Masco Cottons Ltd

44, Redwan Complex, Gazipura Bustand, Tongi, Gazipur
(23.921111N, 90.392778E)
25 January 2015

Observations

Heavily-loaded columns in loading bay area

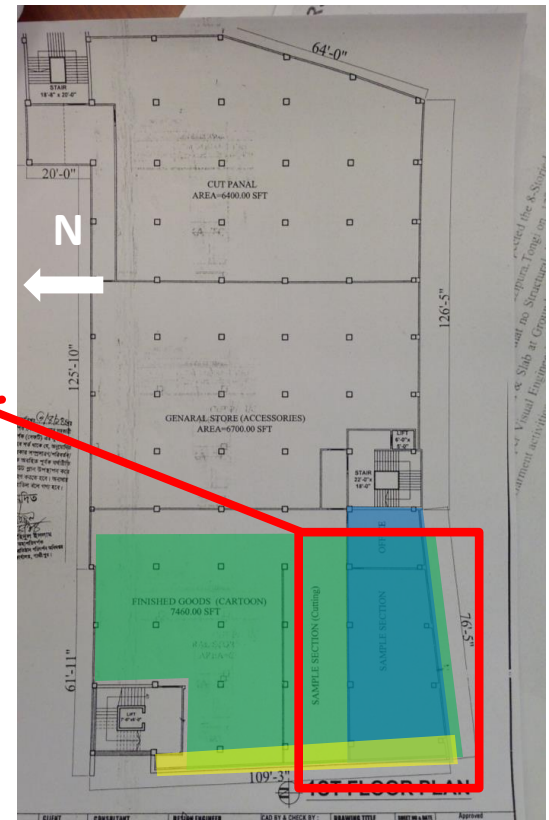
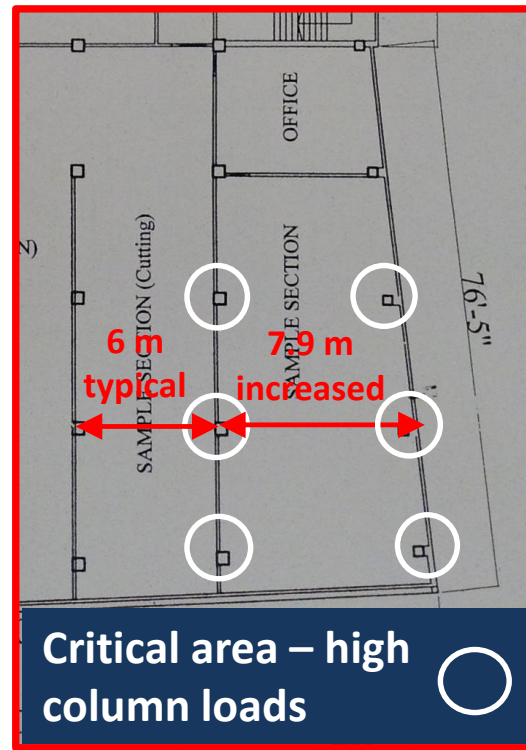
Columns heavily loaded for following reasons:

- Loaded tributary area increased due to larger grid dimension
- Cantilever introduced after design stage
- Loaded columns support storage loads from several floors

Storage load on several floors;
Note: cardboard on 1st floor

Larger as-built grid dimension
than designed

West façade cantilever

Item No.	Observation	Recommended Action Plan	Recommended Timeline
1	Heavily-loaded columns in loading bay area	Restrict Live load on 1st to 7th floors to 2 kPa in area over the loading bays.	Immediate - Now
2	Heavily-loaded columns in loading bay area	Factory Engineer to review design, loads and column stresses in all columns.	Immediate - Now
3	Heavily-loaded columns in loading bay area	Verify insitu concrete stress either by 100 dia cores or existing cylinder strength data for min. 4 no. ground floor front area columns.	Immediate - Now
4	Heavily-loaded columns in loading bay area	A Detail Engineering Assessment of the factory to be commenced, see attached scope.	Immediate - Now
5	Heavily-loaded columns in loading bay area	Revise current loading plan for all floor plates within the Factory and actively manage it, giving consideration to floor capacity and column capacity, particularly in the extended bays over the loading dock.	6-weeks

6	Heavily-loaded columns in loading bay area	Detail Engineering Assessment to be completed.	6-weeks
7	Heavily-loaded columns in loading bay area	Building Engineer to analyse and design the building based on verified concrete and rebar strengths (as outlined in the Detail Engineering Assessment) and as-built structural arrangement in the 6-storey section.	6-weeks
8	Heavily-loaded columns in loading bay area	Carry out any remedial works required by the Detail Engineering Assessment.	6-months
9	Heavily-loaded columns in loading bay area	Continue to implement revised load plan.	6-months

Water storage tanks on roof

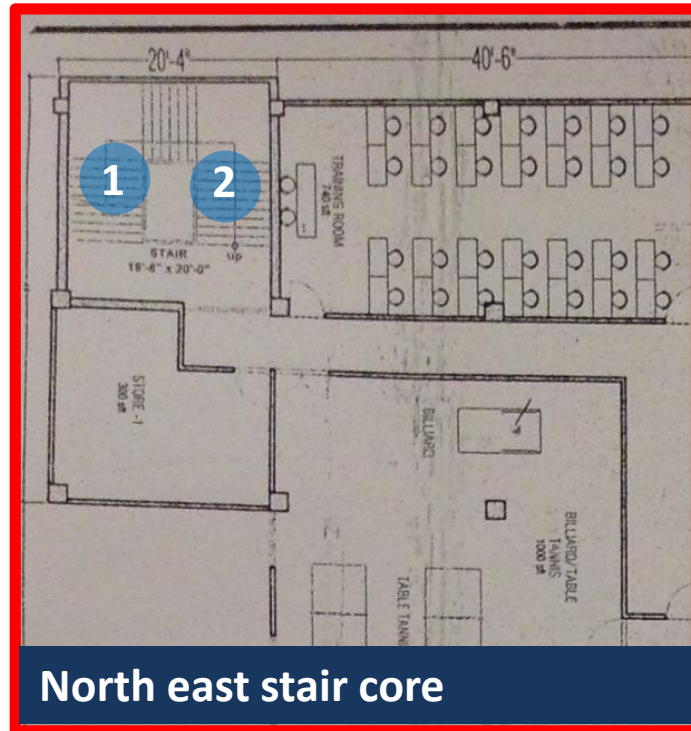
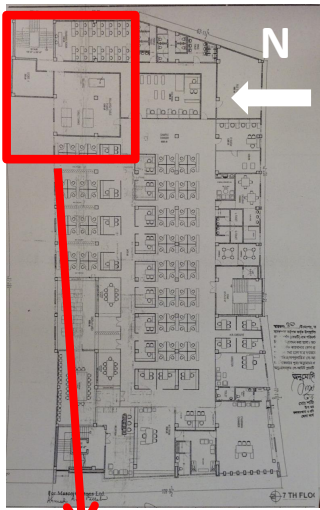
**5000 litre
water tank**

**There are 2 no. water tanks
located above the north east
stair core on the roof. Each
has a capacity of 5000 litres.**

Item No.	Observation	Recommended Action Plan	Recommended Timeline
10	Water tanks on roof of north-east core	As part of the Detail Engineering Assessment (ref. Item 1), the slab supporting water storage tanks to have its design capacity verified by the Building Engineer.	6-weeks
11	Water tanks on roof of north-east core	Remove water tanks if required by Detail Engineering Assessment.	6-weeks
12	Water tanks on roof of north-east core	Carry out any remedial works required by the Detail Engineering Assessment.	6-months
13	Uncontrolled loading (in excess of loading plan) on 1st floor	As part of the Detail Engineering Assessment (ref. Item 1), reduce loading on first floor to conform to revised loading plans.	6-weeks
14	Uncontrolled loading (in excess of loading plan) on 1st floor	Continue to implement revised load plan.	6-months
15	Columns at ground floor level generally appear to be stressed in excess of normal design limits	As part of the Detail Engineering Assessment (ref. Item 1), Building Engineer to review design, loads and columns stresses in area identified above.	6-weeks

Uncontrolled loading 1st floor

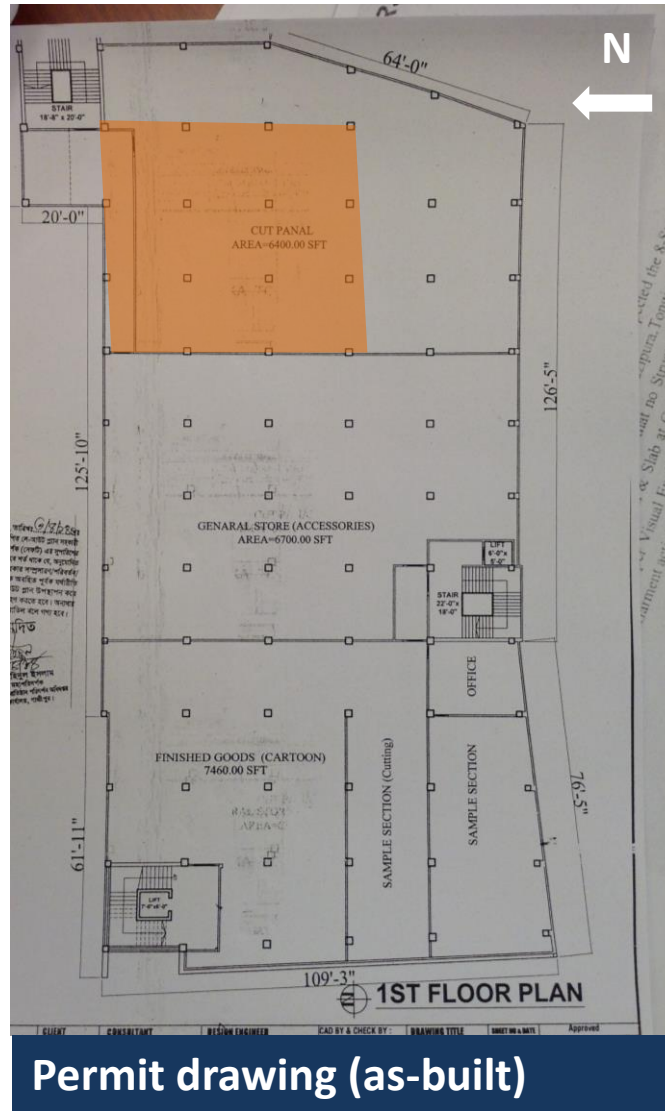
Uncontrolled loading (in excess of loading plan) on 1st floor

High loading
storage of
cardboard and
fabric on 1st floor

7th floor plan

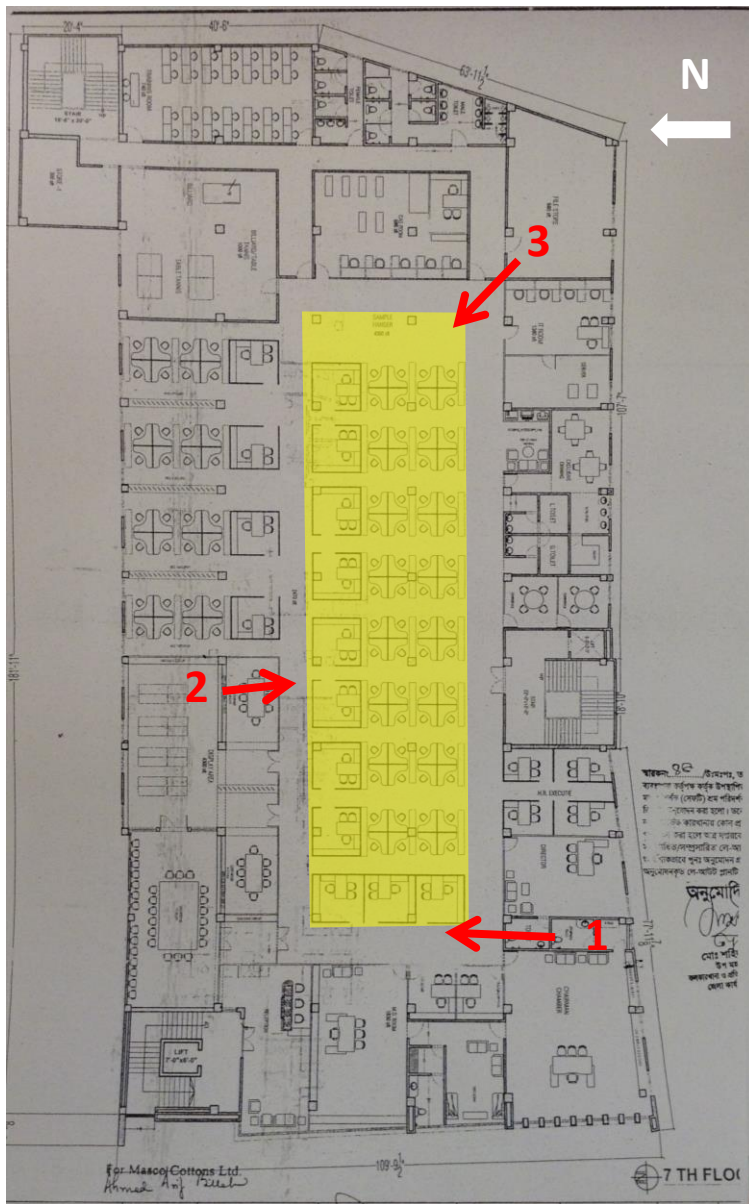
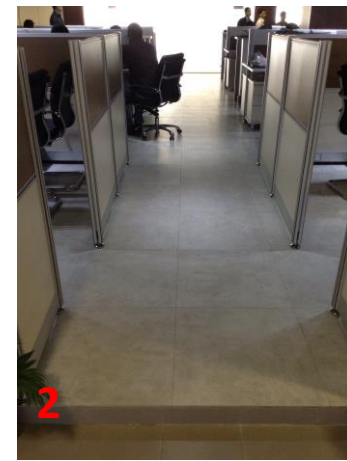
100m thick floor build-up on 7th Floor

**Raised floor level -
100mm thick
additional concrete
(or similar) under
current office
accounts/admin area
– additional dead
load**

**100mm raised
floor**

Item No.	Observation	Recommended Action Plan	Recommended Timeline
17	100mm thick solid screed on 7th floor in office area	As part of the Detail Engineering Assessment (ref. Item 1), Building Engineer to carry out an assessment on the slab / column capacity to carry the additional 100m screed applied on the 7th floor.	6-weeks
18	100mm thick solid screed on 7th floor in office area	Carry out remedial actions arising from Detail Engineering Assessment.	6-months
19	Discrepancies between drawings and actual observation	As part of the Detail Engineering Assessment (ref. Item 1), carry out survey to reflect as-built structure.	6-weeks
20	Discrepancies between drawings and actual observation	Revise engineering drawings as part of Detail Engineering Assessment.	6-months

Structural drawing (design)

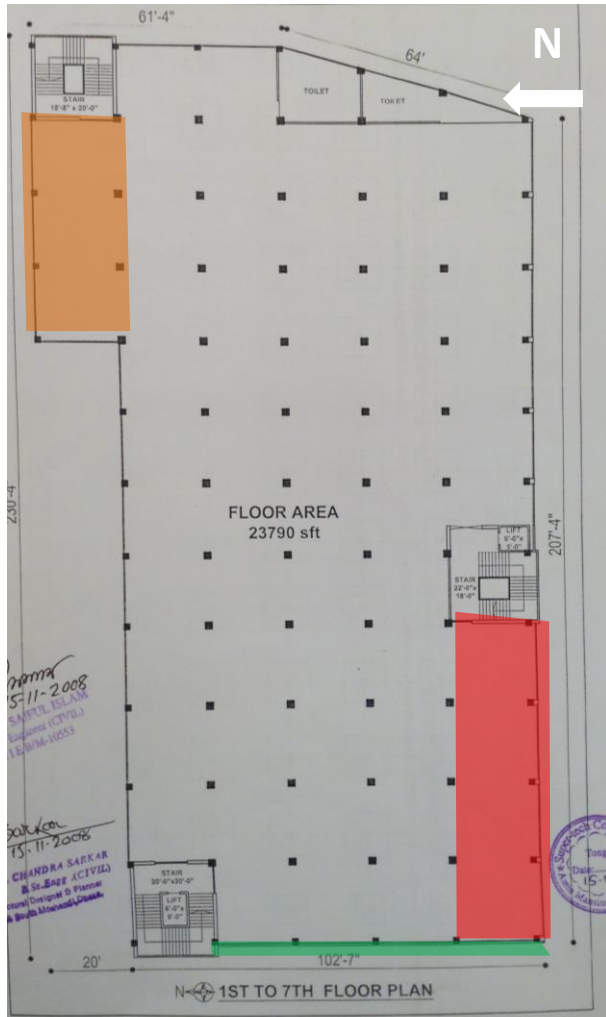
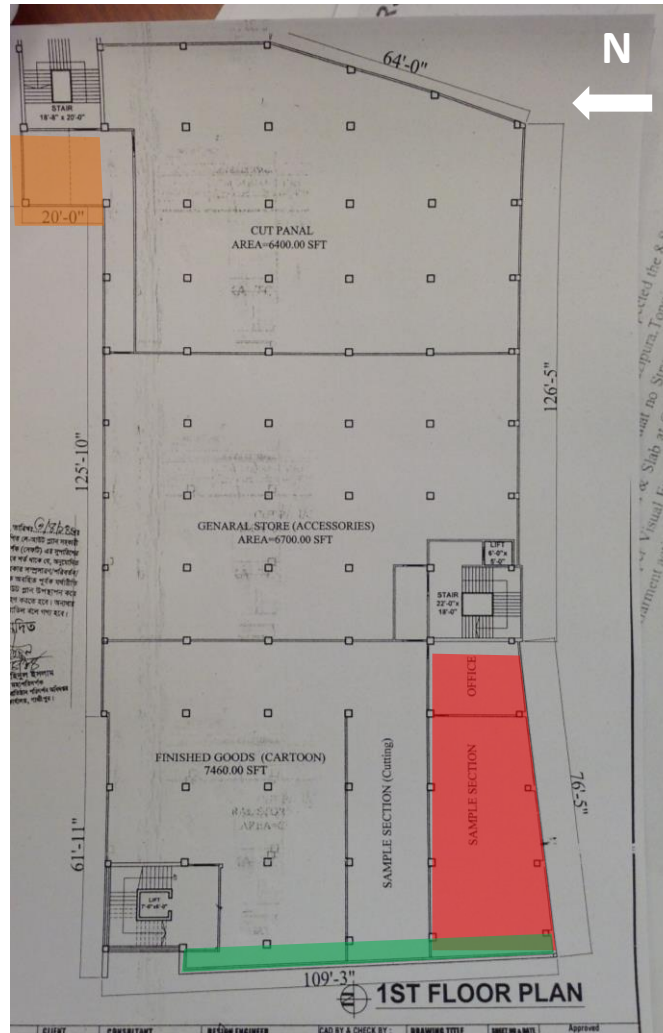
Differences observed between designed and as-built structure

- Column grid widens
- Floor plan reduced
- Cantilever added
